**Meghan Pump Station (RFCSP)  
Solicitation Number: CO-00645  
Job No.: 19-1006**

**ADDENDUM 2  
October 17, 2023**

**SAN ANTONIO WATER SYSTEM**  
**MEGHAN PUMP STATION**  
**ELECTRICAL CONTROL**  
**DIAGRAM SHEET 2 OF 8**

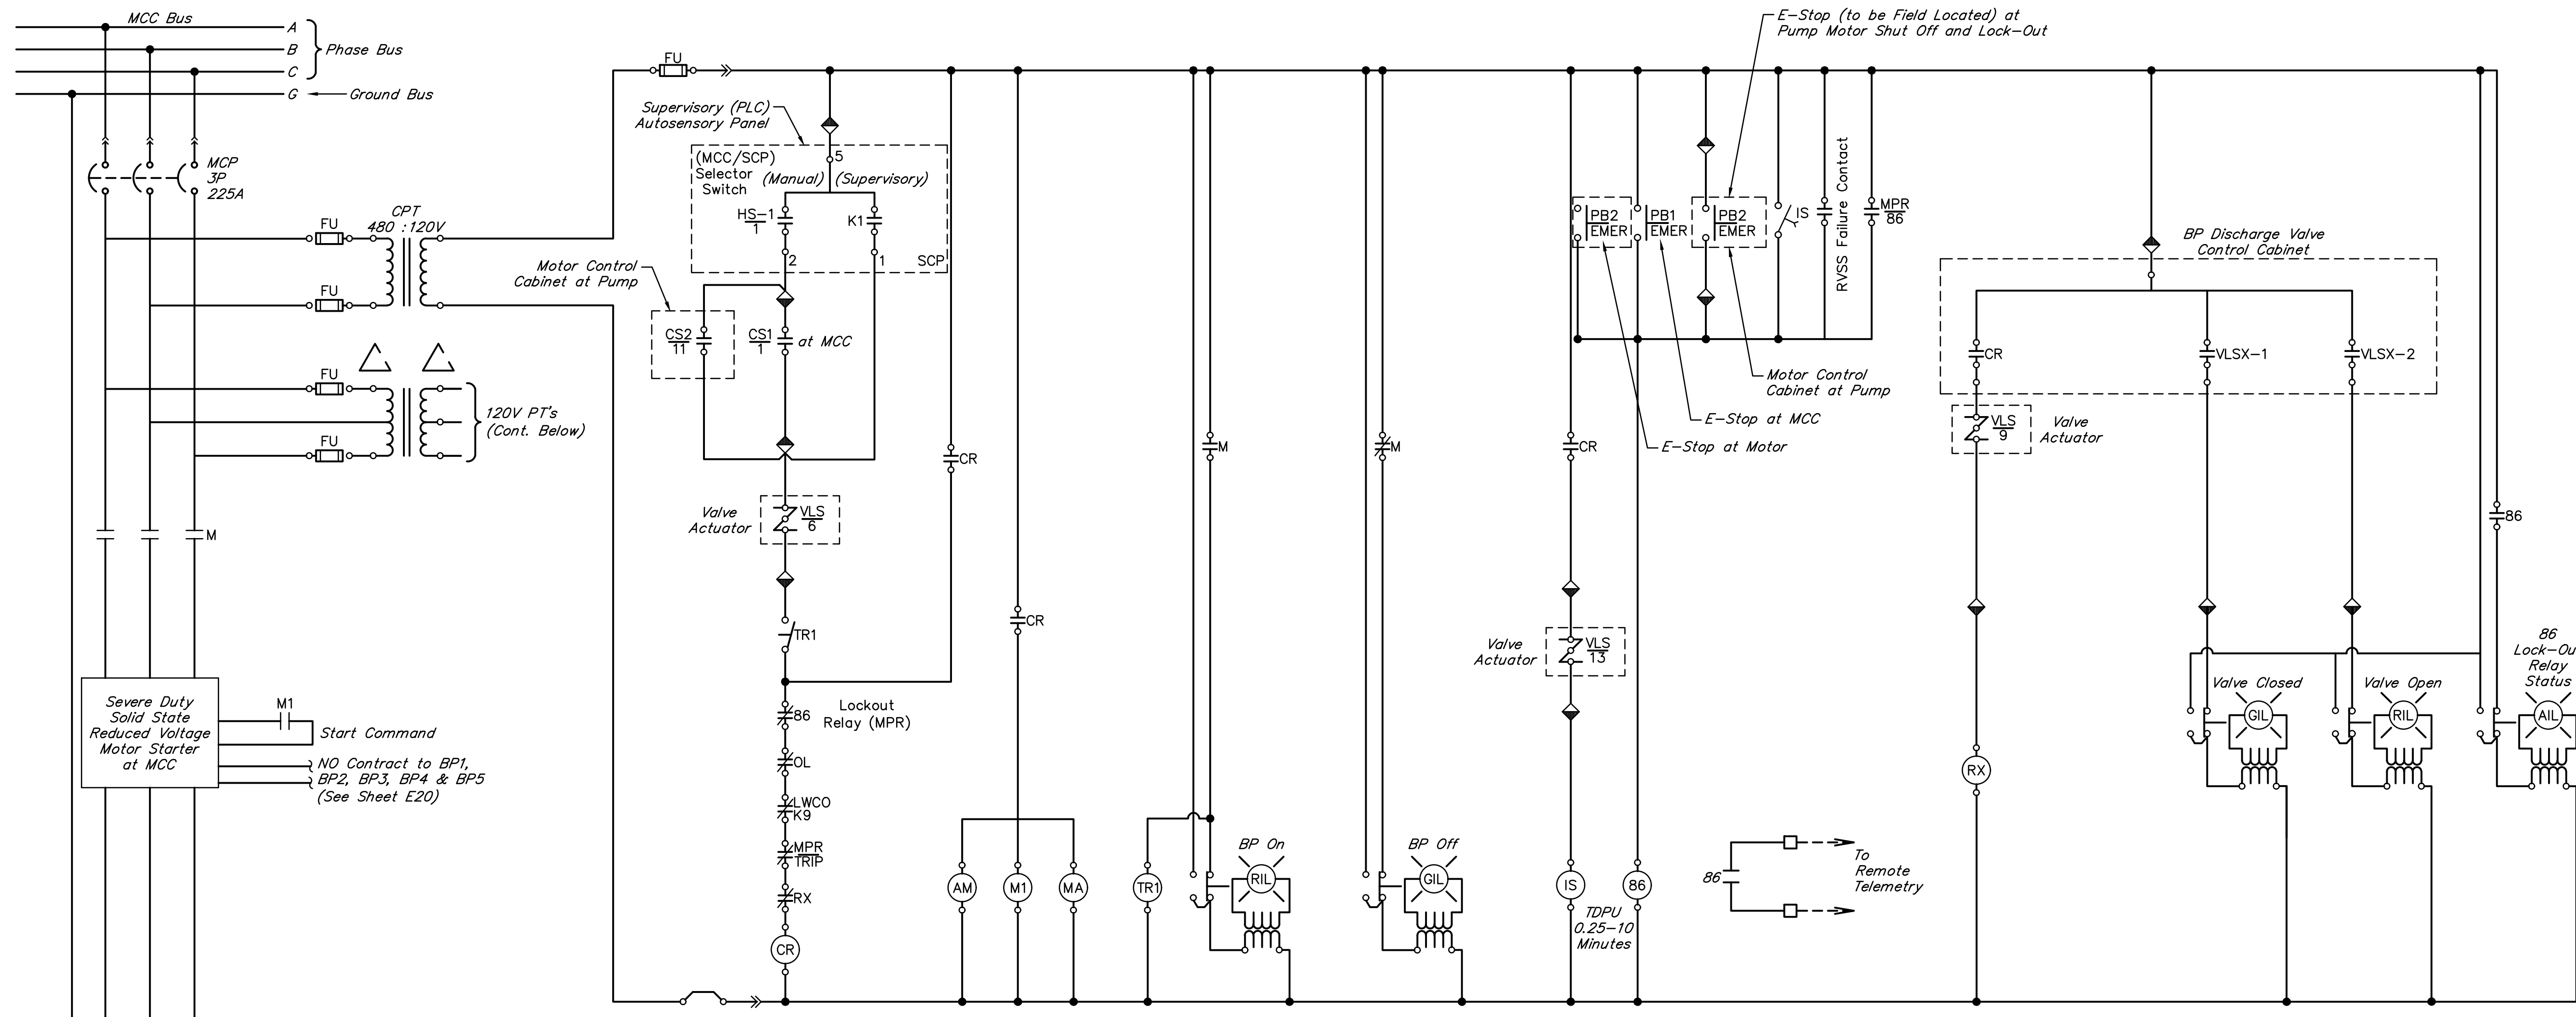
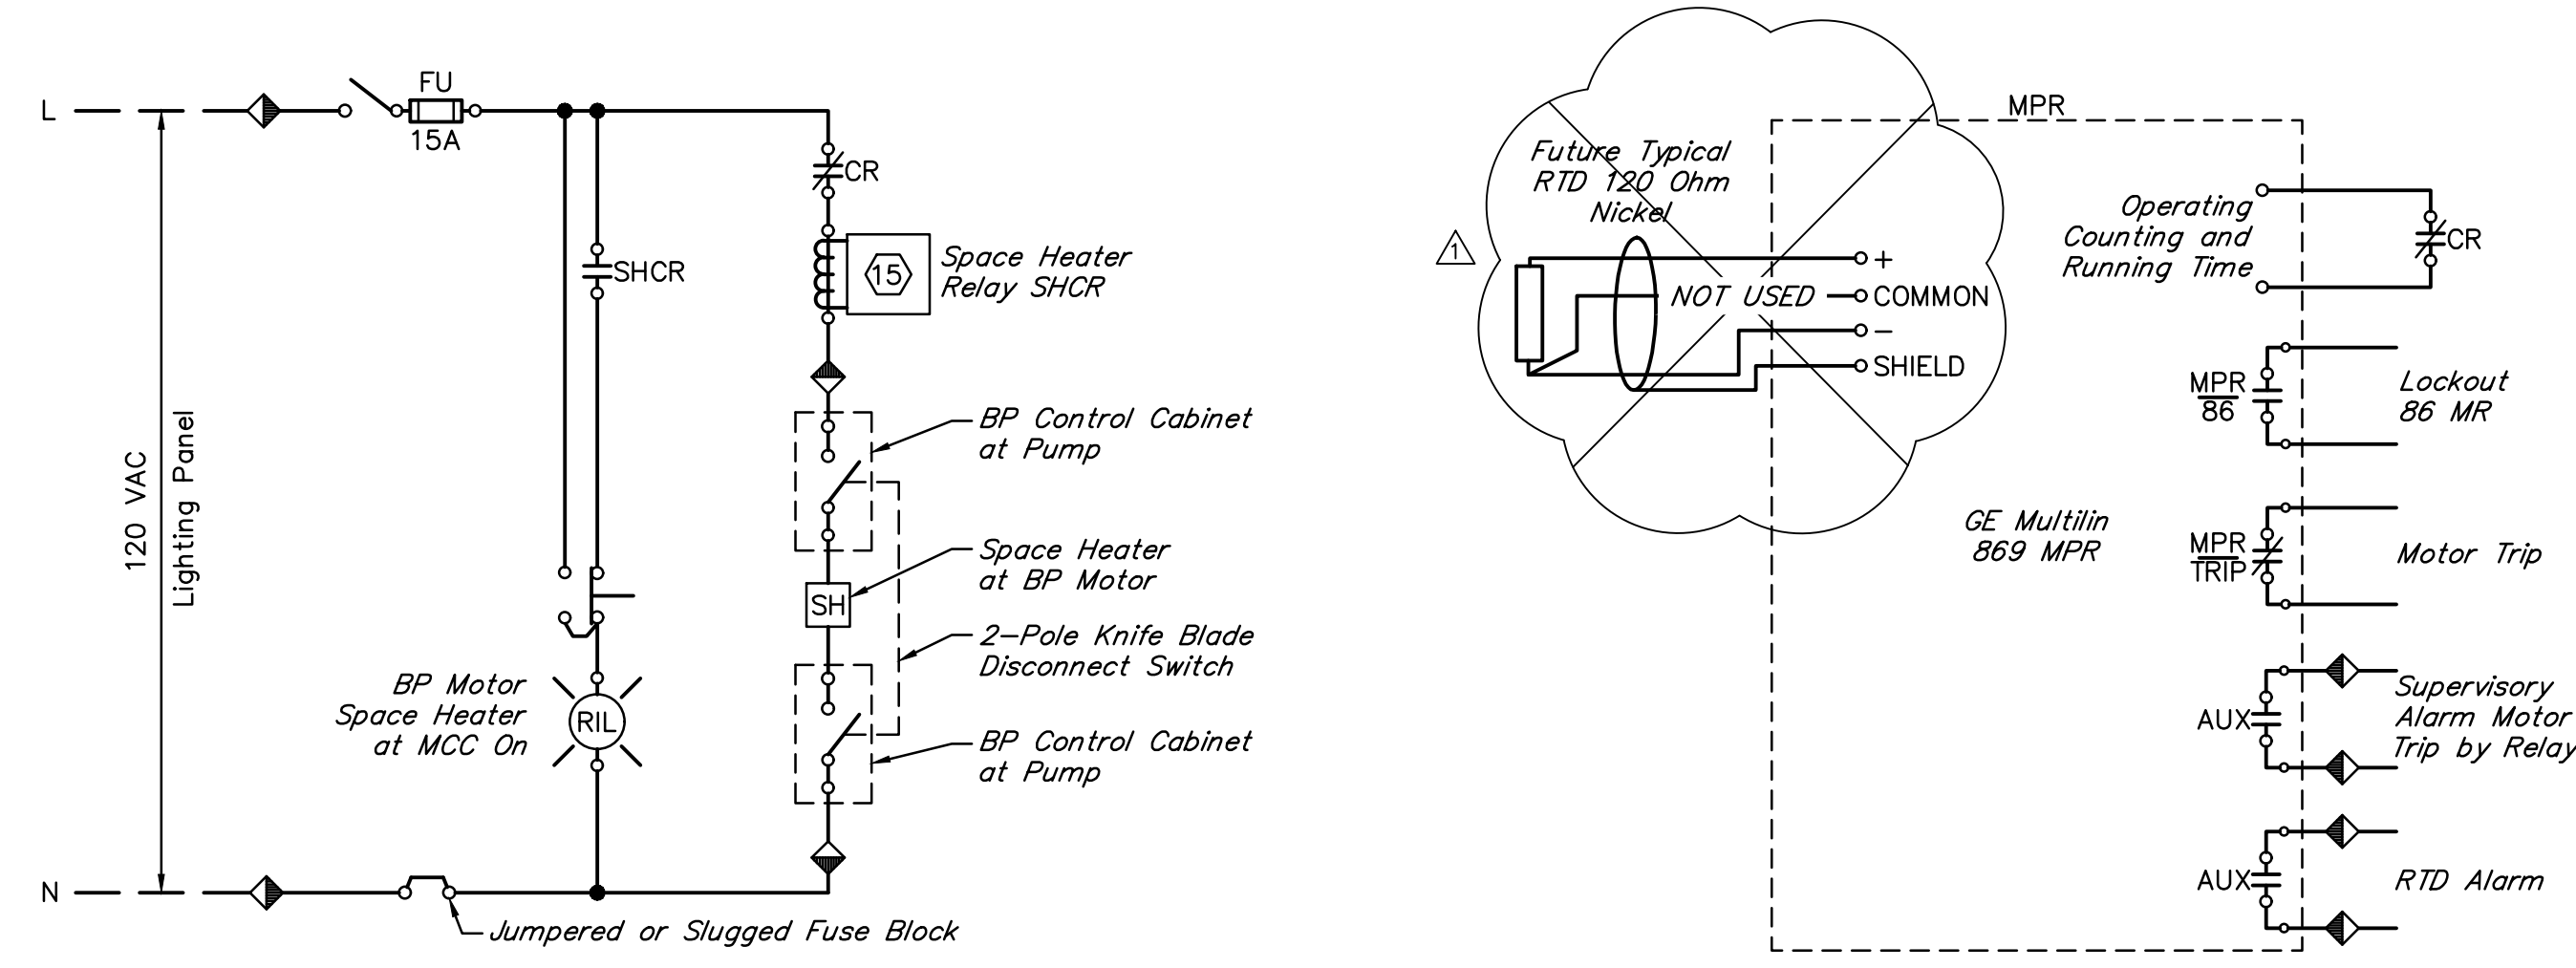
69. Motor Specification Section 16013 2.04 C calls to provide the booster pump Power Factor Correction Capacitors as required to conform to motor manufactures requirements to correct motors power factor to .95 without overexciting the motor. It is to be installed withing 10 circuit feet from the solid state reduced voltage motor starter; In Vertical Turbine Pump Spec Section 15230 it does not mention power factor capacitors in the motor specifications in this section.

*Response: See #1, Changes to the Specifications, in this addendum. PFCC are required and shall be installed as indicated in plans. Specification 15230, Section 2.5.A was modified to include the following: Provide power factor capacitor as required to conform to motor manufacturer requirement to correct the motor's power factor to 0.95 without overexciting the motor. Power factor to be installed a minimum of 10 circuit feet from the solid state reduced voltage motor starter.*

SHEET NO. **E12**  
 46 OF 67

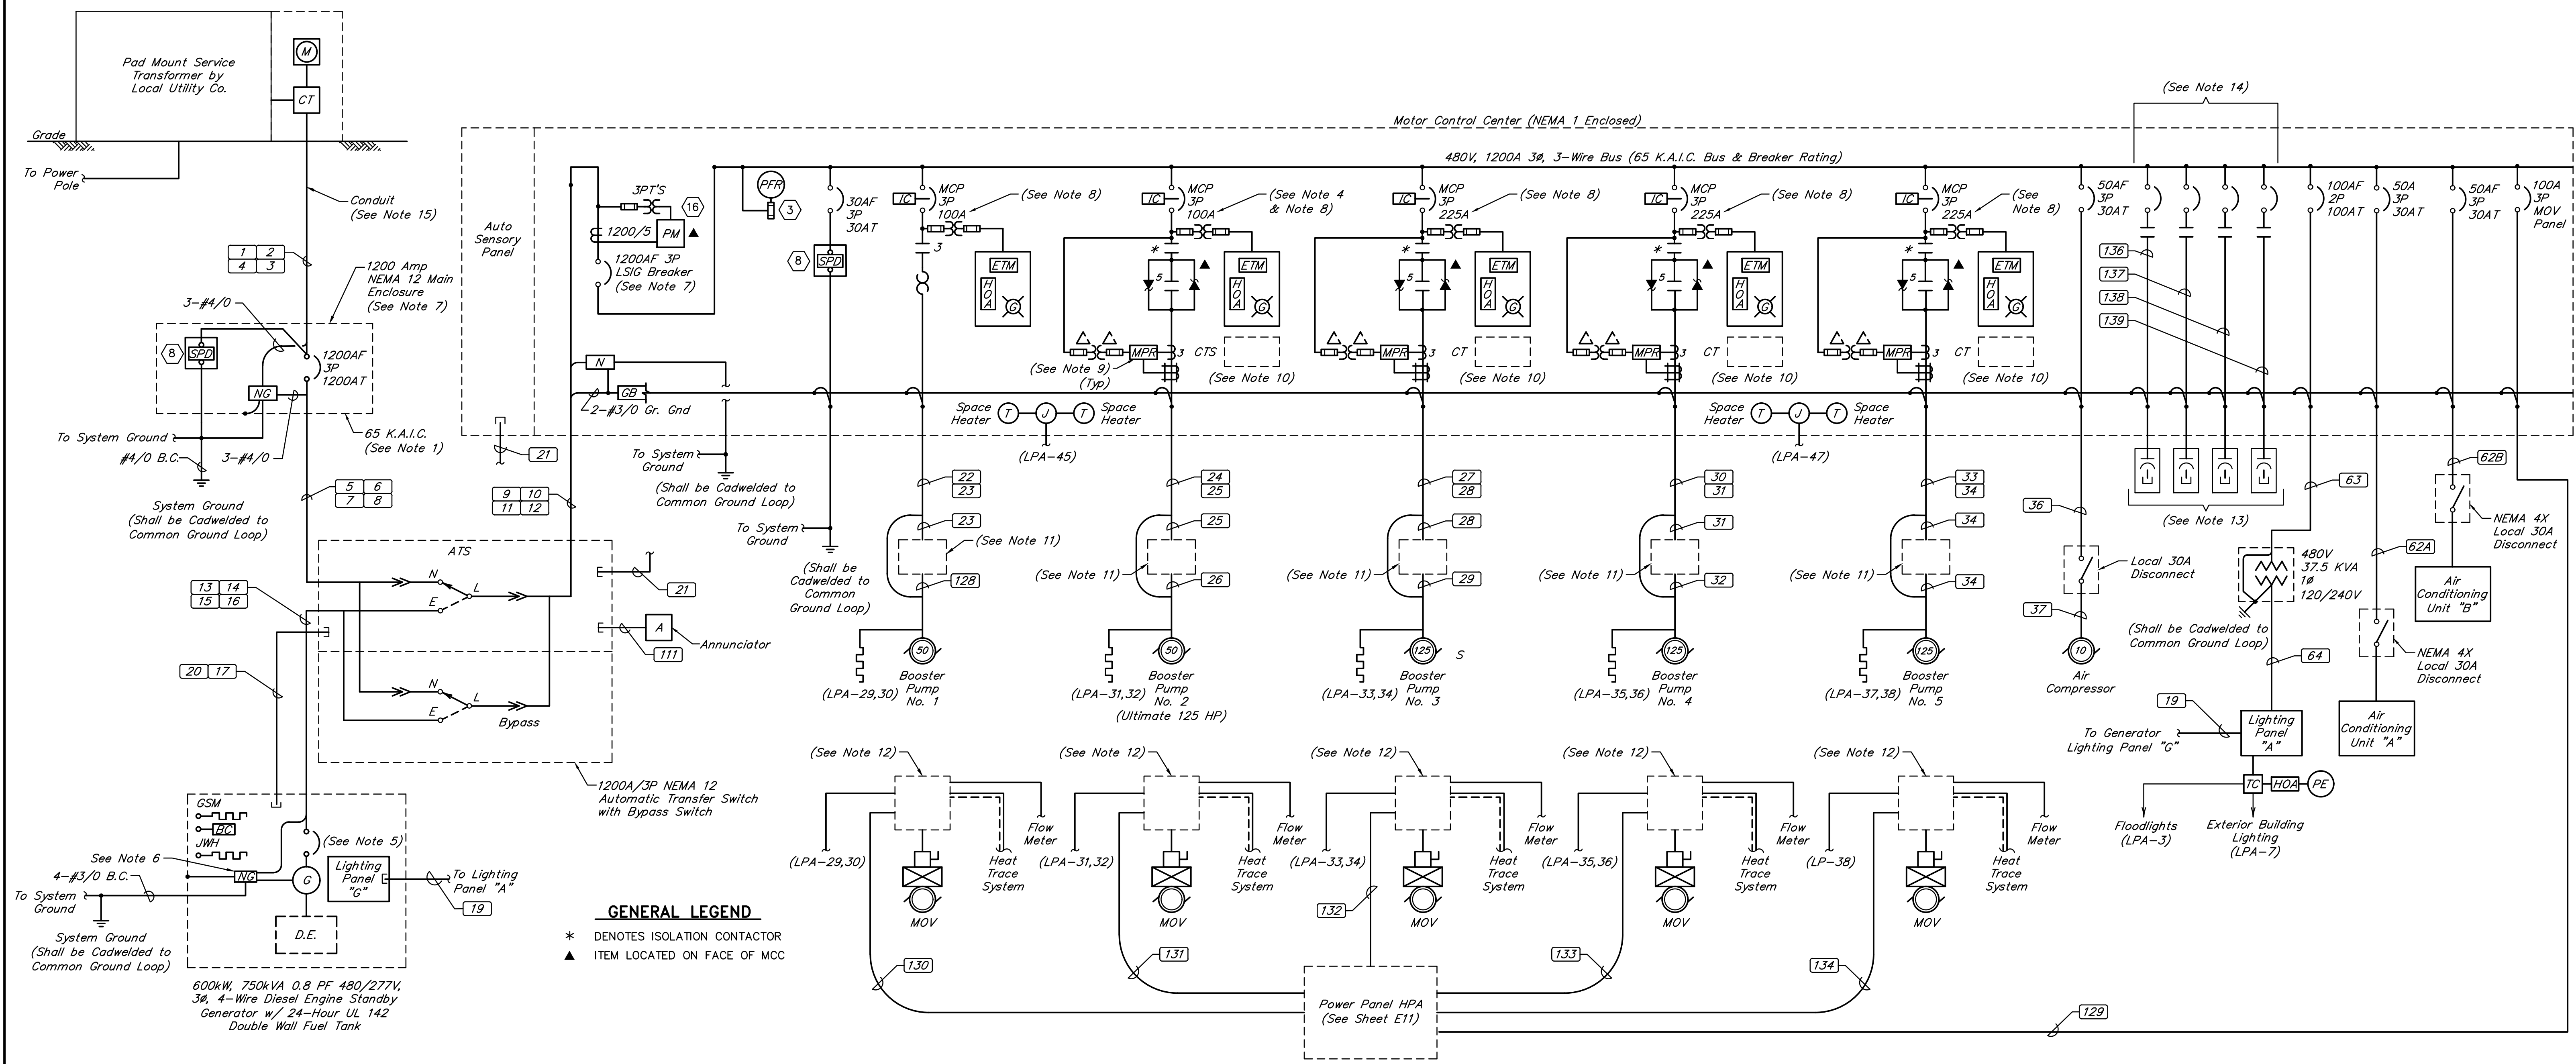
**58.** On sheet E12, Note 15, the last sentence states the secondary service from CPS Transformer to the Main Disconnect conductors are to be provided by SAWS. Does that apply to ALL 3-#400MCM, 1-#3/0 NEU, 1-#3/0 G circuits? Conduit #'s 5 - 16 are same type of cabling as # 1 – 4. Please review and clarify the intention.

70. Note 13 on Sheet E12 states “Provide and Install Power Factor Correction Capacitor as provided by motor Manufacture as stated for the basis of bid. Mount Capacitors to top of Motor Control Center. Provide 30 circuit feet of wire from MCC Base.” Power Factor Correction Capacitors are typically mounted in the MCC and provided by the gear supplier, but it appears the intent is to have these provided by the motor manufacture and mounted in a separate enclosure above the MCC. Is it acceptable to have the gear supplier include this and have it located inside the MCC?

*Response: Conductors shall be provided by the contractor and installed per CPS Energy and SAWS requirements. See #5, Changes to the Plans, in this addendum. The indicated revision to the has been made. Note 15 on Sheet E12 has been modified.*

*Response: PFCC inside the MCC is not acceptable. PFCC may be provided by either motor manufacturer or gear supplier as long as they conform to the motor manufacturer requirements and they shall be mounted in separate enclosure above the MCC as stated in Sheet E12, Note 13.*
